Access Compliance Report

Public Rights-of-Way

Intersection ID: 50240	Main Street: LONGSTONE_LN	Cross Street: CEDAR_WALK_LN	Location: E
ADA ID: BF4AF32FBBED	Ramp Type: BlendTrans1	Initial Pass/Fail: Fail	Overall Compliance: No
		Severity Score: 12.5

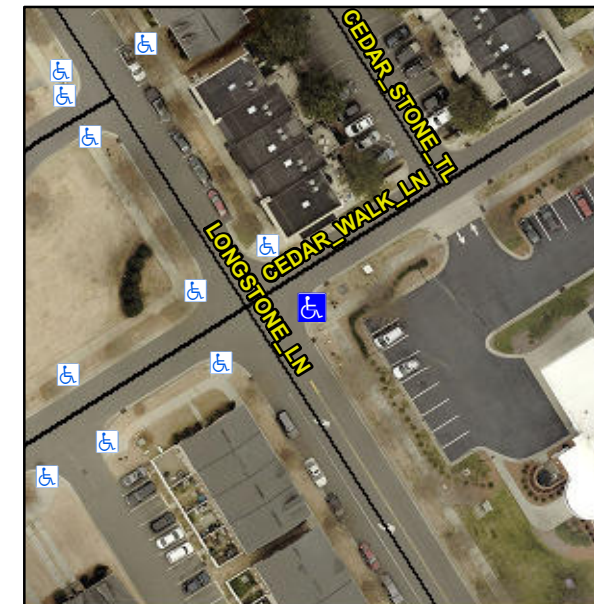
Not Found, R304.5.3

Compliance	Description	Data	Compliance	Description	Data
N/A	Ramp Length (in)	96.0	Yes	BlendTrans Slope (%)	4.5
Yes	Ramp Width (in)	48.0	No	BlendTrans XSlope (%)	6.2
N/A	Flare Type LT	N/A	N/A	Flare Type RT	N/A
N/A	Flare Slope LT (%)	N/A	N/A	Flare Slope RT (%)	N/A
N/A	Flare Traversable LT?	N/A	N/A	Flare Traversable RT?	N/A
N/A	Landing Length (in)	N/A	N/A	DWS Provided?	N/A
N/A	Landing Width (in)	N/A	N/A	DWS Contrast?	N/A
N/A	Landing Slope (%)	N/A	N/A	DWS Length (in)	N/A
N/A	Landing X Slope (%)	N/A	N/A	DWS Full Width?	N/A
N/A	Landing Curb? (Y/N)	N/A	N/A	DWS Offset (in)	N/A
N/A	Shared Landing?	N/A			
N/A	Gutter Ponding?	N/A	N/A	Gutter Slope (%)	N/A
N/A	Gutter Lip Ht (in)	N/A	N/A	Gutter X Slope (%)	N/A
N/A	Painted X Walk1?	No	N/A	Painted X Walk2?	No
	X Walk 1 Direction	To NW		X Walk 2 Direction	To SW
	X Walk 1 Width (in)	N/A		X Walk 2 Width (in)	N/A
	X Walk 1 Slope (%)	2.8		X Walk 2 Slope (%)	2.5
	X Walk 1 X Slope (%)	3.5		X Walk 2 X Slope (%)	3.3

N/A	Ramp inside XWalk1?	N/A	N/A	Ramp inside XWalk2?	N/A
	Road Slope (%)	4.4		Clear Space?	N/A
	Road X Slope (%)	2.0	N/A	Clear Space to XWalk (in)	N/A
N/A	Any Obstructions?	N/A	N/A	Storm Grate/Utility Hazard?	N/A
	Obstruction Type			Storm Grate/Utility Type	
		N/A			N/A
			Yes	Surface Condition? (G/P)	Good
			No	Curb Slope (%)	10.0

Remove & Replace Curb Ramp With Two New Directional Ramps or Equivalent.
